McCONNEL

2, 3 & 5-Wheel Gate Drives

New Model for 2013

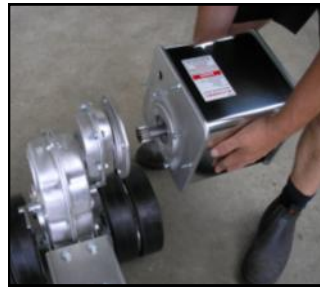
New Pelton Wheel:

- Shaft is supported between bearings giving better bearing life.
- Stronger cast cover.

Simplified Freewheel Clutch:

- Easy lock in lock out operation.
- Lever is less exposed to cow damage.

Stronger Chassis:

- Stronger corrosion resistant aluminium side plates.
- Larger mount plate for easier welding to the gate.

No Fuss Motor & Pelton Wheel Removal:

- Motor or pelton wheel can be removed from outside the gear casing.
- Saves time and effort if repairs are needed.

Improved Front Wheel:

- Dry lube front bearings increase life for those who forget to grease them.
- Tapered wheel nuts for better wheel security.
